**TO:** T10 Membership  
**FROM:** Paul A. Suhler, Quantum Corporation  
**DATE:** 11 April 2008  
**SUBJECT:** T10/07-469r2, ADT-2: Internet ADT (iADT)

**Figure 12 – Example of shared iADT socket in an automation device**

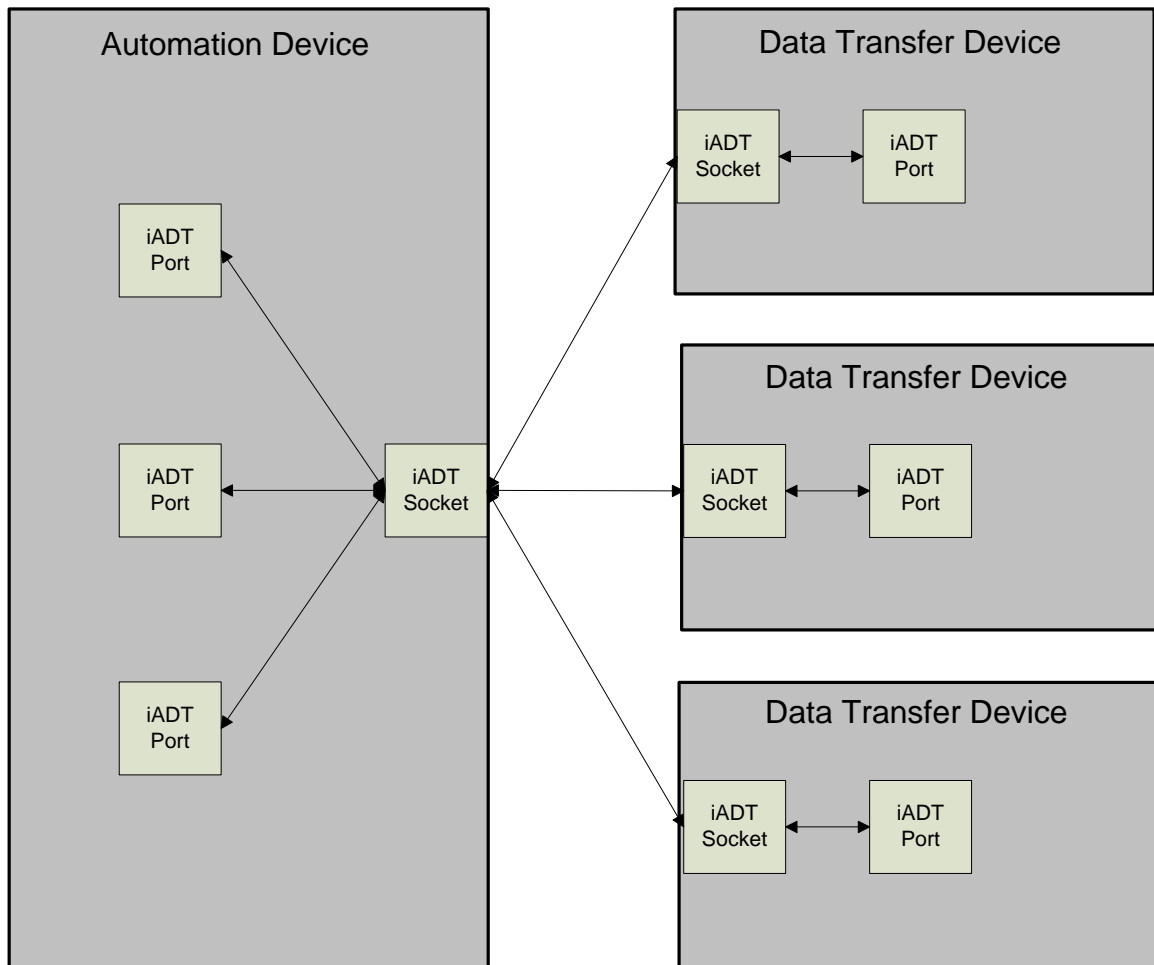
One physical network port may respond to multiple internet addresses, and thus may contain multiple iADT sockets, one for each of the internet addresses. If a device (e.g., device A) contains only one iADT socket (i.e., there is one Ethernet port and it responds to a single internet address) then that iADT socket may be connected to iADT sockets in different devices. Each of those iADT connections connects to a different ADT port in device A. (See Figure 12.)
